ELECTRONIC APPLICATION OF GREEN	)	
RIVER SOLAR, LLC FOR A CERTIFICATE TO	)	
CONSTRUCT AN APPROXIMATELY 200	)	
MEGAWATT MERCHANT SOLAR ELECTRIC	)	CASE NO. 2020-00387
GENERATING FACILITY IN BRECKINRIDGE	)	
COUNTY AND MEADE COUNTY, KENTUCKY	)	
PURSUANT TO KRS 278.700 AND 807 KAR	)	
5:110	)

## RESPONSES TO SITING BOARD STAFF'S POST-HEARING REQUEST FOR INFORMATION

TO GREEN RIVER SOLAR, LLC
DATED NOVEMBER 3, 2021
GREEN RIVER SOLAR, LLC
PSC CASE NO. 2020-00387

Case No. 2020-00387 Green River Solar, LLC

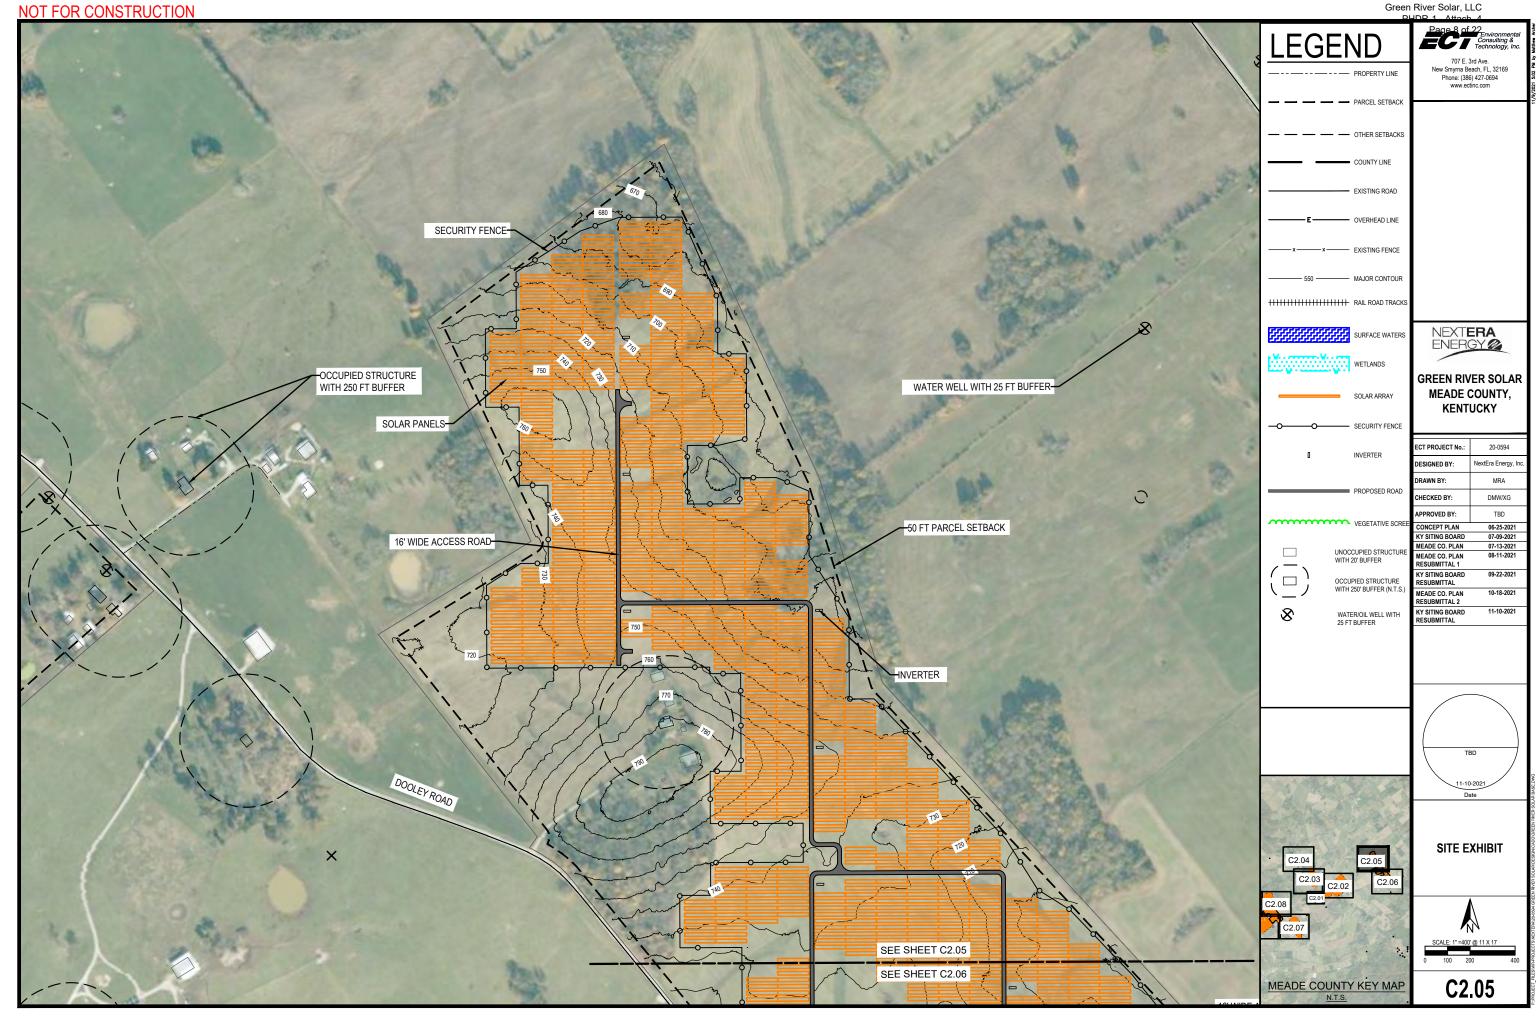
Request 4. Provide a copy of the Site Plan with updated and detailed proposed vegetative buffers. If any residences with direct view of solar facilities or equipment will have no vegetative buffering, explain why.

Please see Attachment 4 for updated Conceptual Site Plan, including updates to proposed vegetative buffers. Vegetative buffers are planned for all residences with direct view of the solar facilities or equipment.
